Staff Report

Item: 2145 Molalla Rd NE, "Woodburn Eastside Apartments" (ANX 2019-01)

Annexation ANX 2019-01 (Type IV) with proposed site development DR 2019-06 Woodburn Eastside Apartments: Commission recommendation to the City Council.

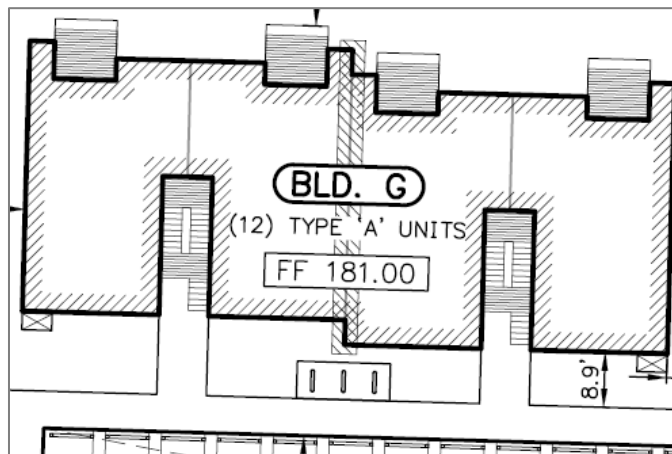
- (4) Guest: Of the stalls outdoors 2 stalls min within 10 to 15 ft of ROW and along or near the access way;
 - (5) Front: 2 stalls min outside each apt building spaced to conform to the 50-foot distance provision of WDO 3.05.03E as applied through a Design Review (D) condition – and in addition to and more specifically than that condition, also near the front of each building. The diagram below illustrates what “near the front” means:

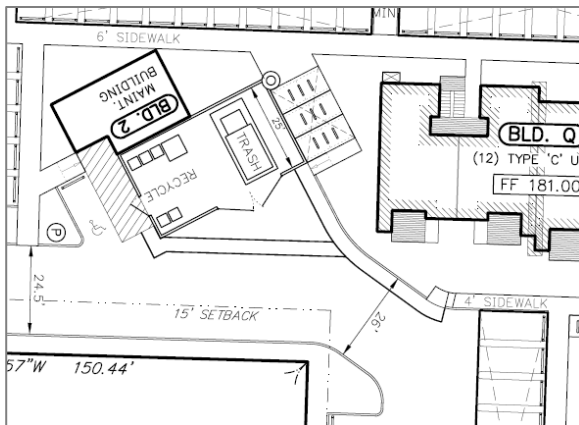
D2. Street corridor: To meet WDO 3.01, as proposed as part of recordations and regarding Street Corridor “C”, the developer shall dedicate a PUE of 82 ft min width across the north end of the subject property, and shall revise the draft easement text to contain:

- a. In the body or an Exhibit C, a description that the easement serves to implement Woodburn Comprehensive Plan Policy H-2.2 and Transportation System Plan (TSP) Figure 6 (2019) by reserving on the subject property a segment of Street Corridor "C" for a future street that would connect Cooley Road and either or both June Way and U.S. 99E and that would be ROW of 72 ft width with remainder 5-ft PUEs along the south side or both sides; and
- b. One instance min of the phrase "street reservation and public utility easement" in any of the title, body, map Exhibit B, or an Exhibit C.

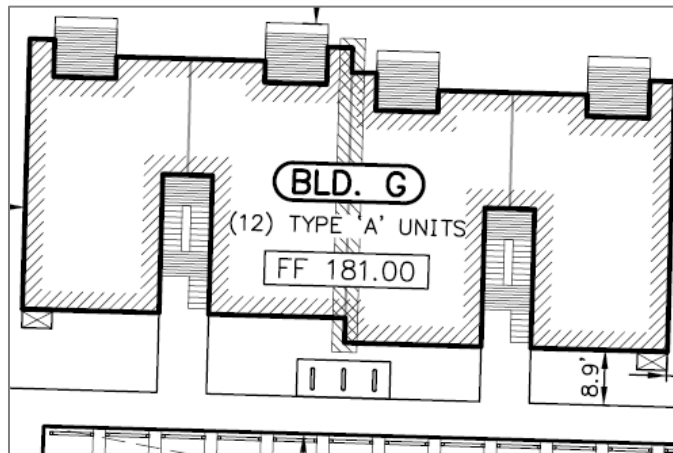
- (4) Guest: Of the stalls outdoors 2 stalls min within 10 to 15 ft of ROW and along or near the access way;
 - (5) Front: 2 stalls min outside each apt building spaced to conform to the 50-foot distance provision of WDO 3.05.03E as applied through a Design Review (D) condition – and in addition to and more specifically than that condition, also near the front of each building. The diagram below illustrates what “near the front” means:

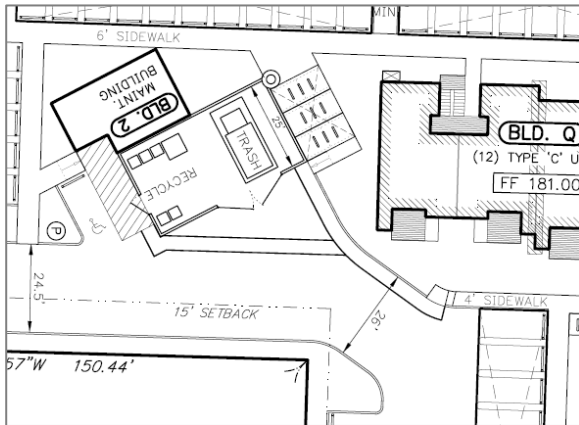
D2. Street corridor: To meet WDO 3.01, as proposed as part of recordations and regarding Street Corridor “C”, the developer shall dedicate a PUE of 82 ft min width across the north end of the subject property, and shall revise the draft easement text to contain:

- a. In the body or an Exhibit C, a description that the easement serves to implement Woodburn Comprehensive Plan Policy H-2.2 and Transportation System Plan (TSP) Figure 6 (2019) by reserving on the subject property a segment of Street Corridor “C” for a future street that would connect Cooley Road and either or both June Way and U.S. 99E and that would be ROW of 72 ft width with remainder 5-ft PUEs along the south side or both sides; and
- b. One instance min of the phrase "street reservation and public utility easement" in any of the title, body, map Exhibit B, or an Exhibit C.
